14 February 2025

ADDENDUM NO. 3

RE: Chisholm Creek Utility Authority  
Wastewater Treatment Facility Improvements  
WCI File: 20-600-514-00

SHEET NO:  
**D-124**

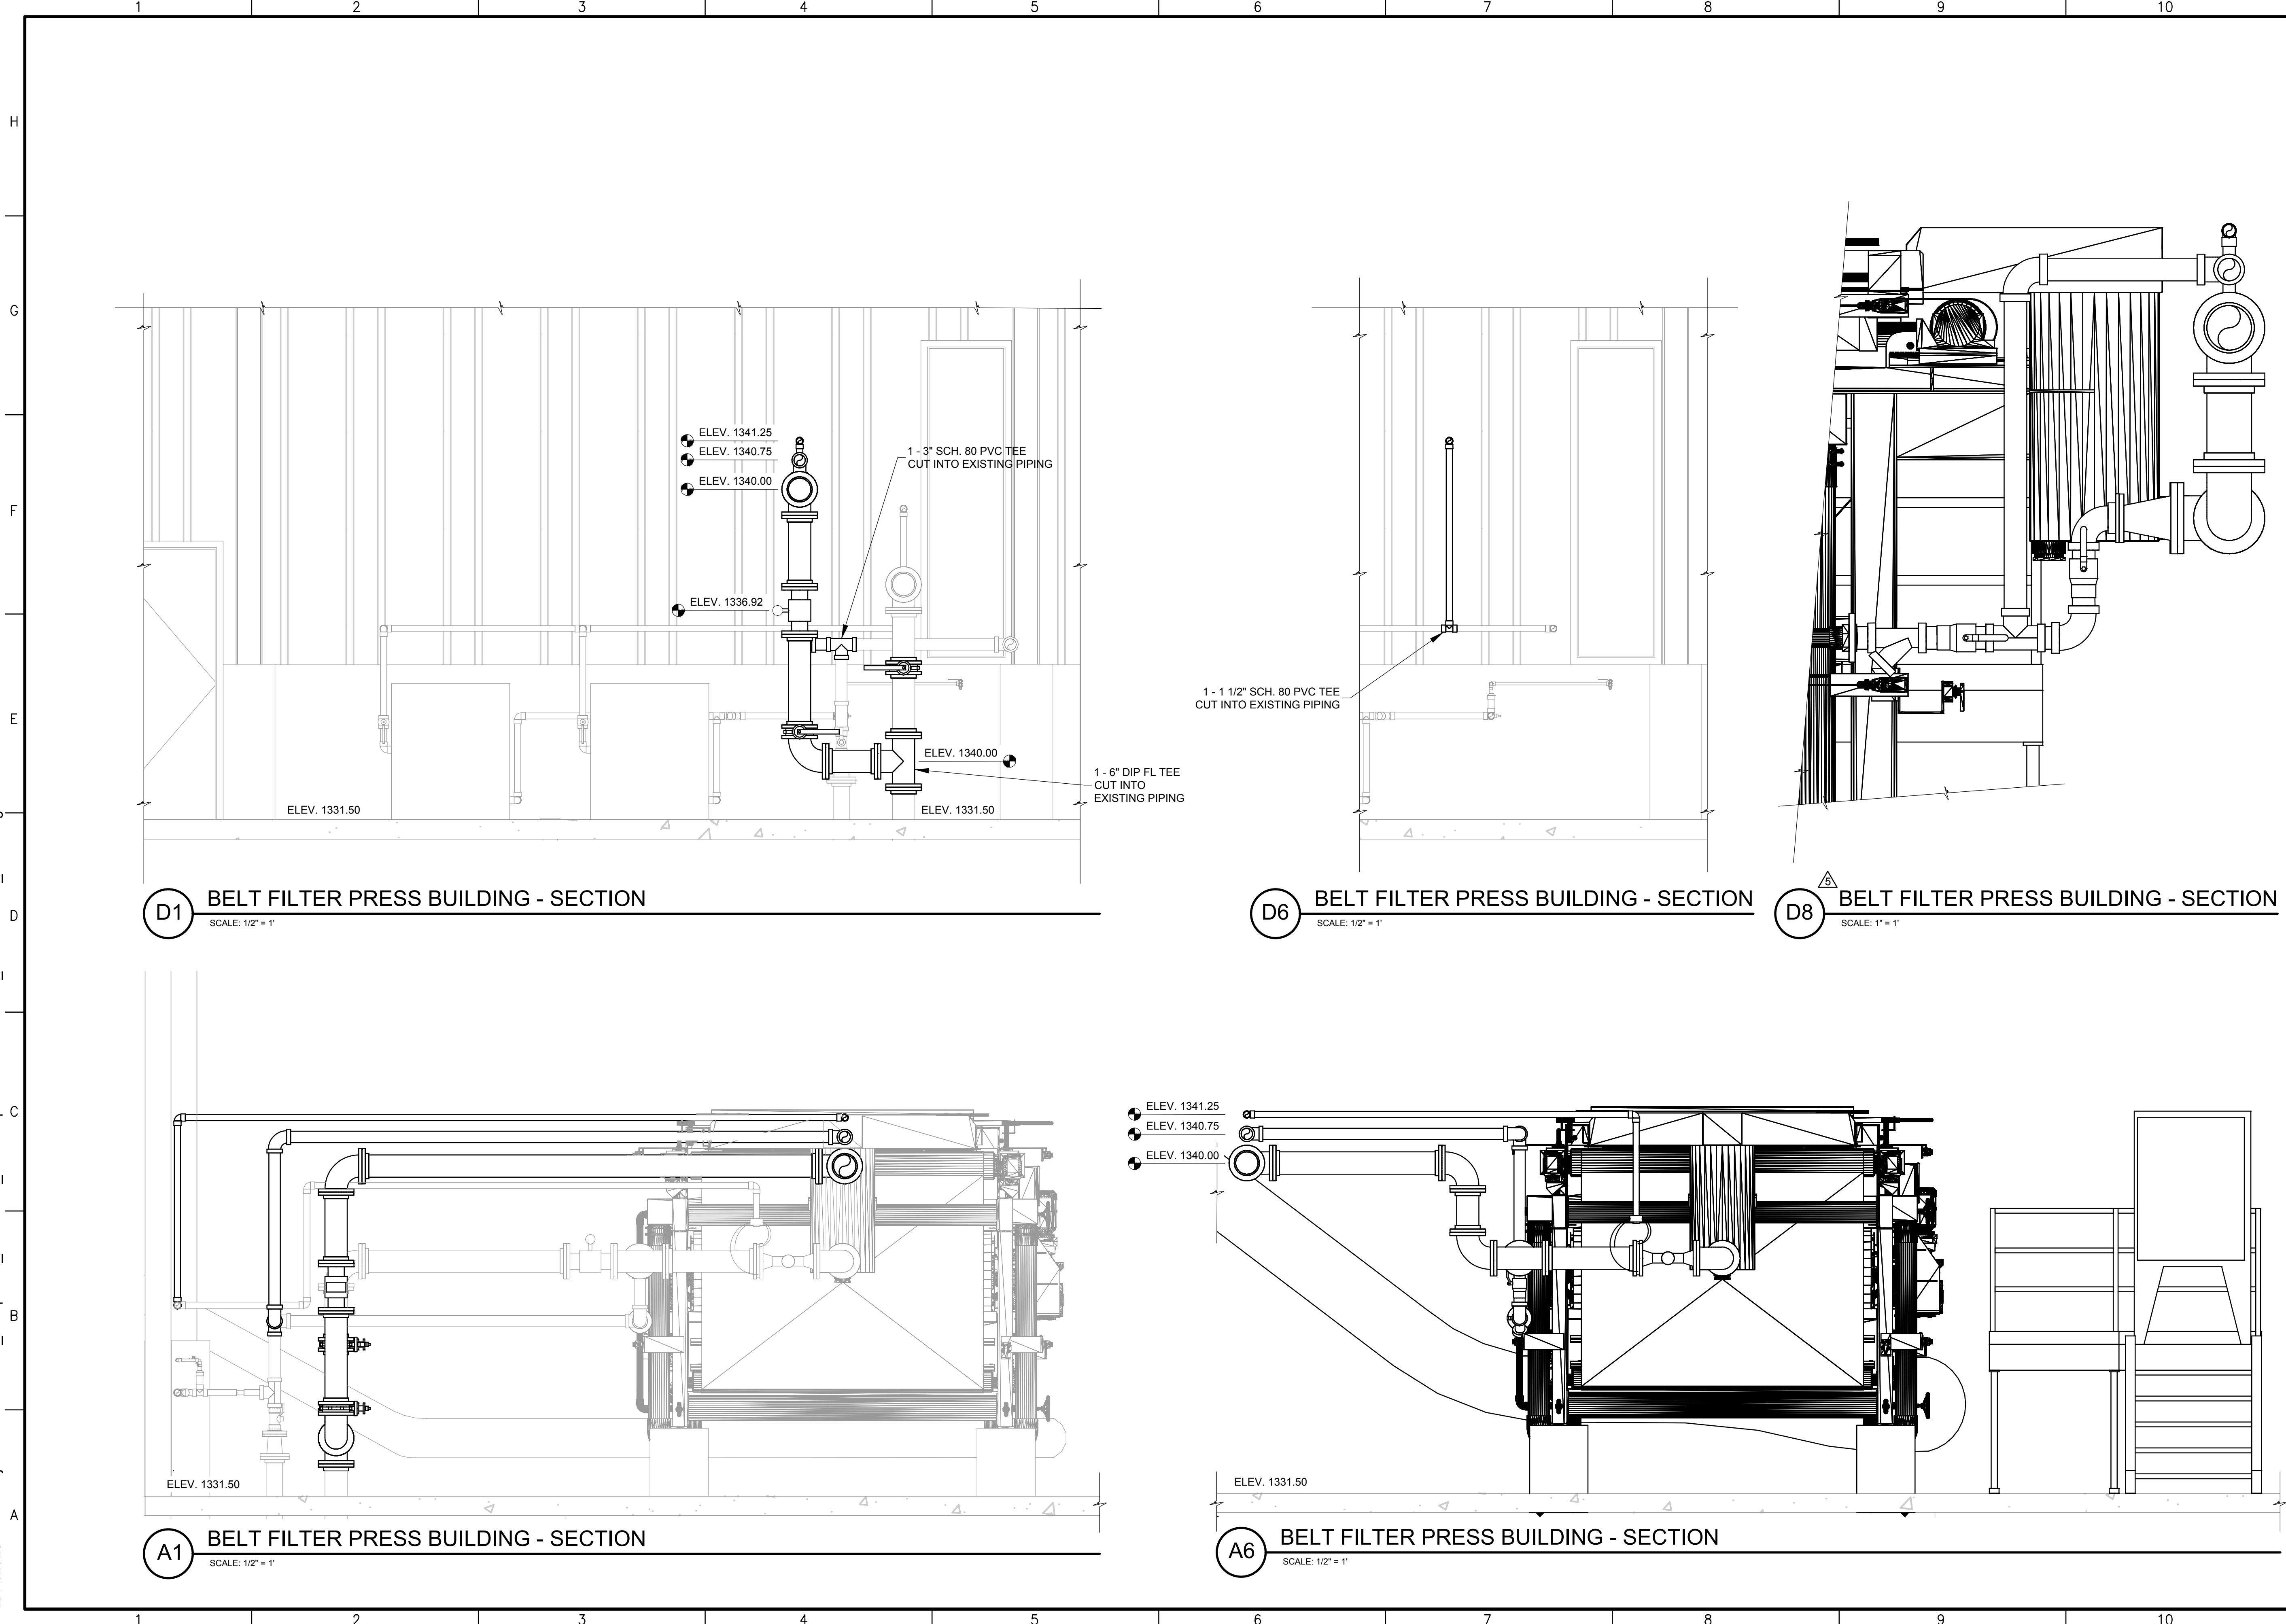
1. Sheet No. D-504  
CLARIFICATION that both existing plan views and the section view have a scale of  $\frac{1}{2}'' = 1'$ .
2. Sheet No. S-116  
CLARIFICATION to Concrete Water Cement Ratio shall not exceed 0.45 as stated in the specifications.
3. Sheet No. D-508  
CLARIFICATION that V920 (2" Ball Valve) is a manual valve as indicated on D-301, and not an actuated valve as indicated on Valve Schedule sheet D-508.
4. Sheet No. D-312  
CLARIFICATION that V410 and V411 shown in Section A8 are provided by Evoqua as part of their scope in Section 11400C in the Project Manual, and are not to be provided by Contractor as indicated on Valve Schedule sheet D-508.
5. Sheet No. D-124  
REMOVE and REPLACE sheet with attached Sheet D-124. The new sheet adds Construction Notes and Callouts #15-#17.

SHEET NO:  
**D-104**

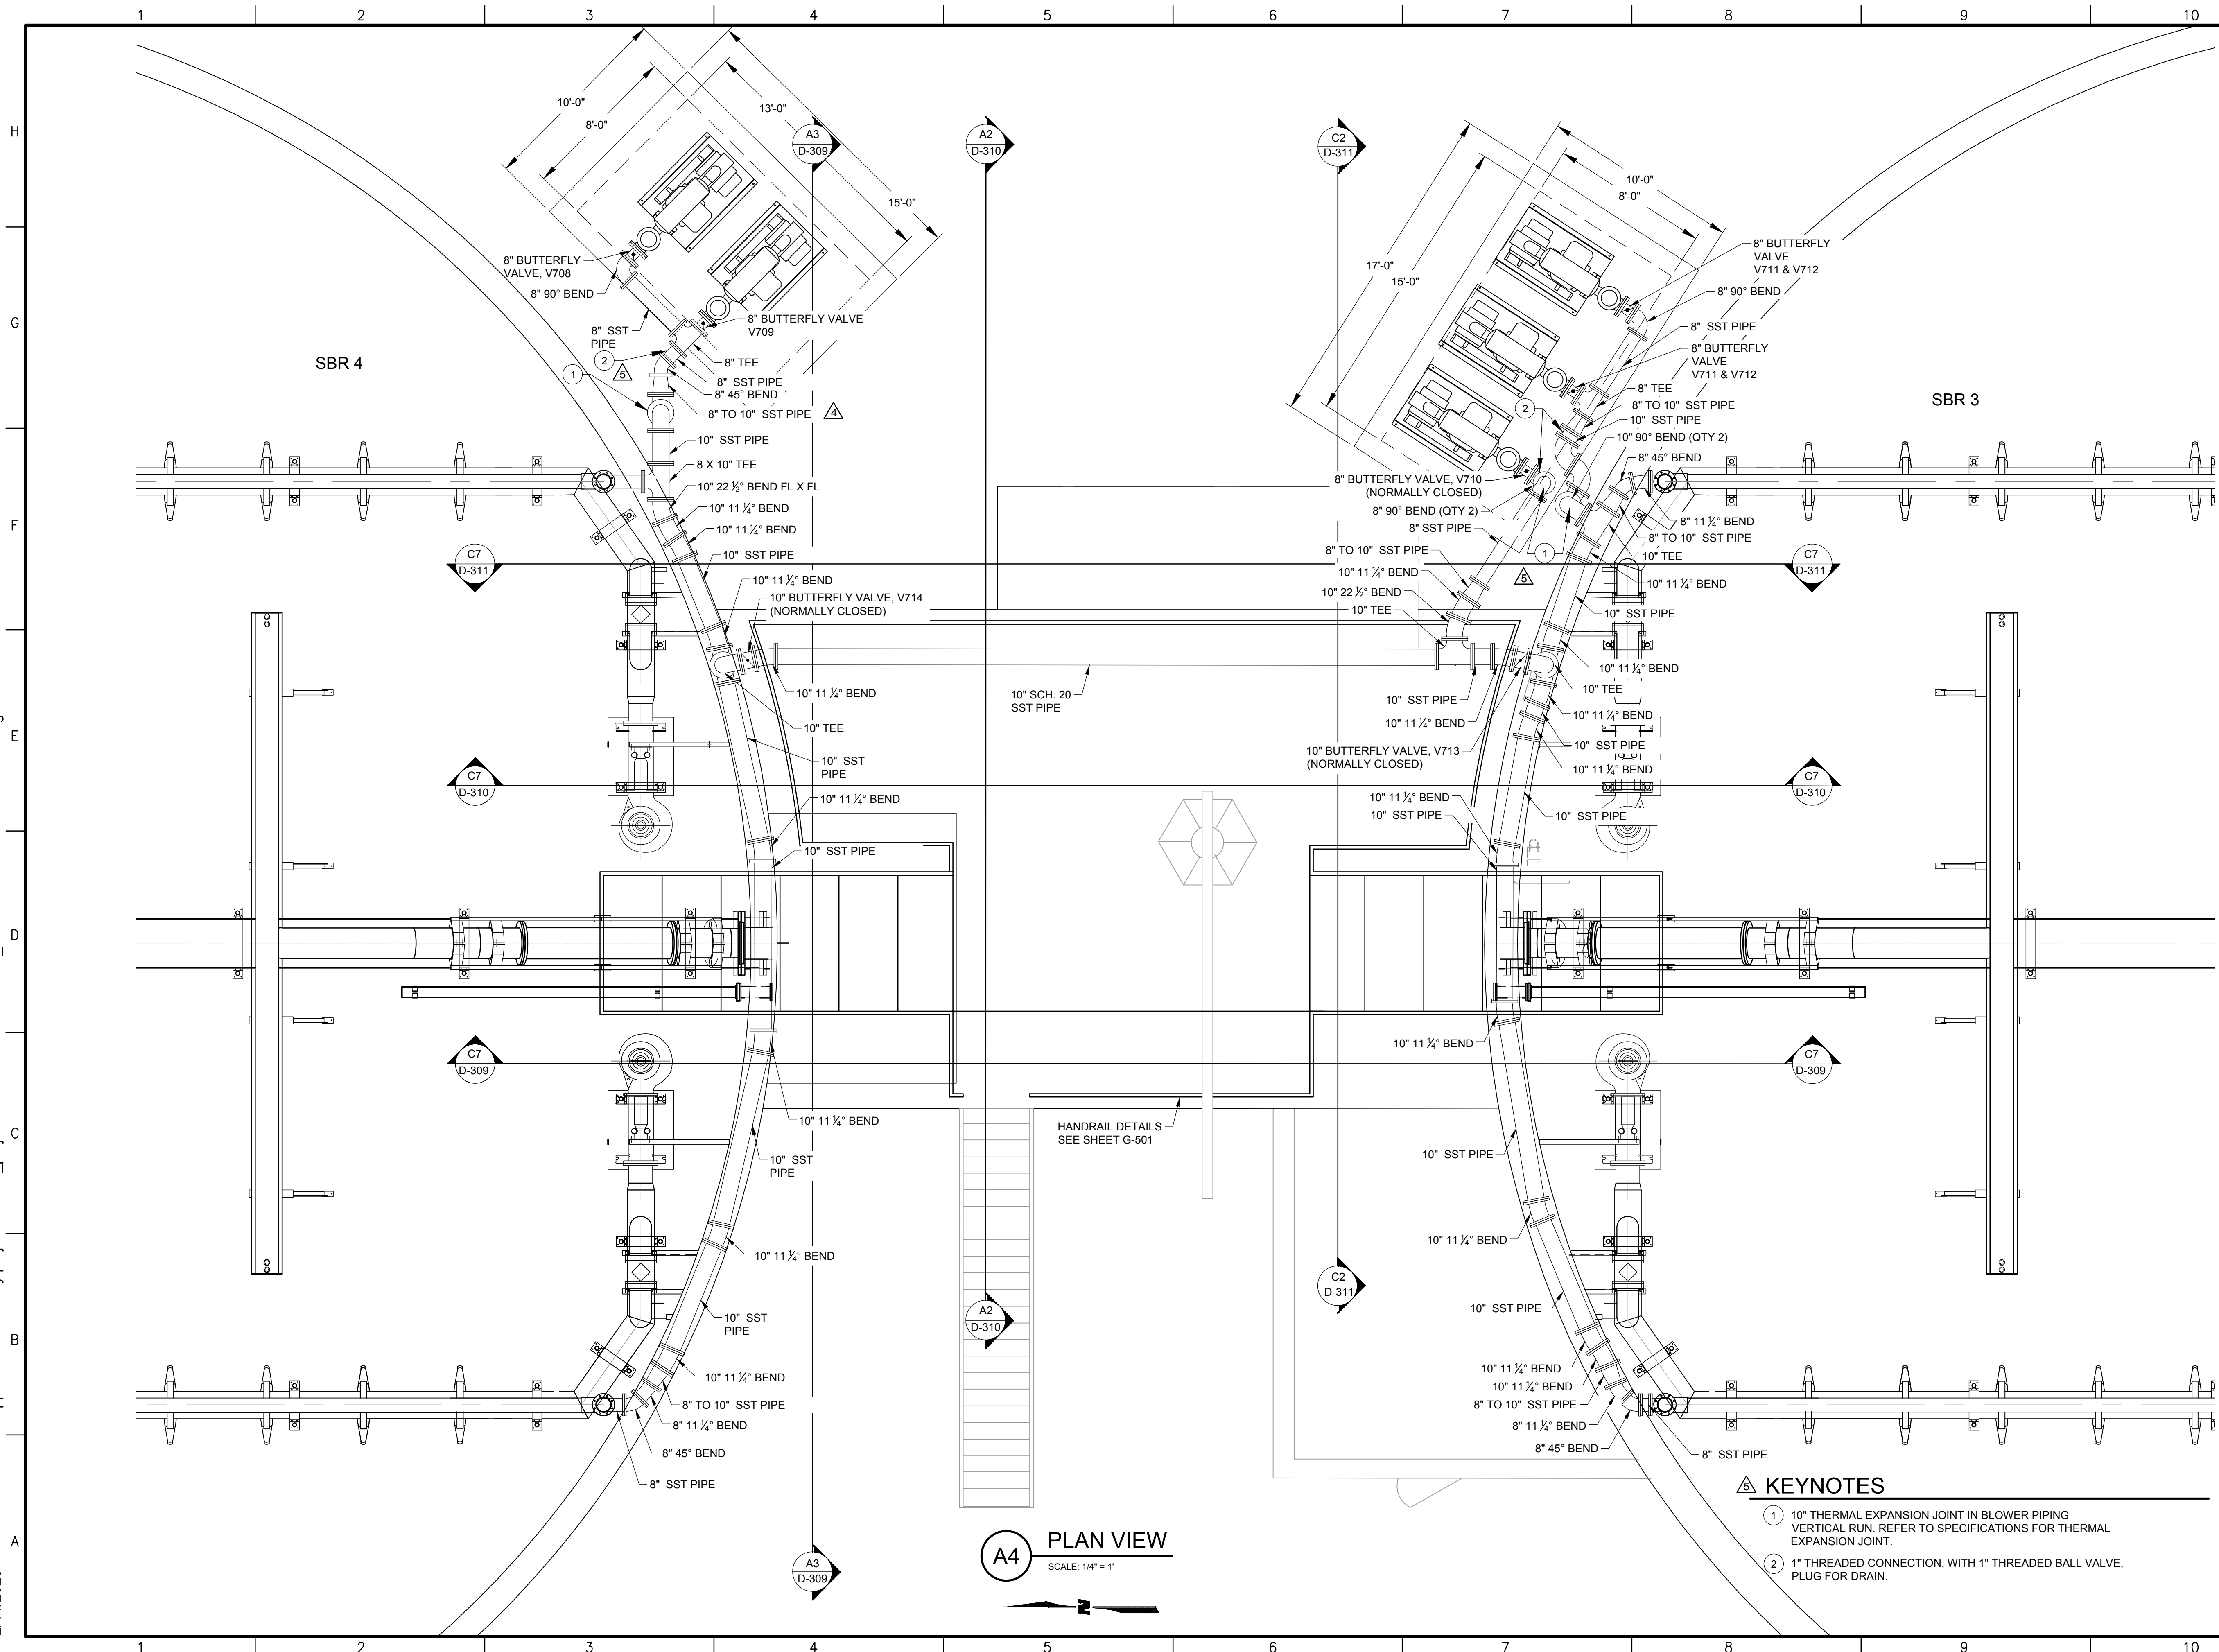
7. Sheets No. D-104 & D-110  
ADDITION of Keynotes #1 and #2 referencing installation of Thermal Expansion Joints and Threaded Connection with Ball Valve for draining.

- ① 10" THERMAL EXPANSION JOINT IN BLOWER PIPING VERTICAL RUN. REFER TO SPECIFICATIONS FOR THERMAL EXPANSION JOINT.
- ② 1" THREADED CONNECTION, WITH 1" THREADED BALL VALVE, PLUG FOR DRAIN.
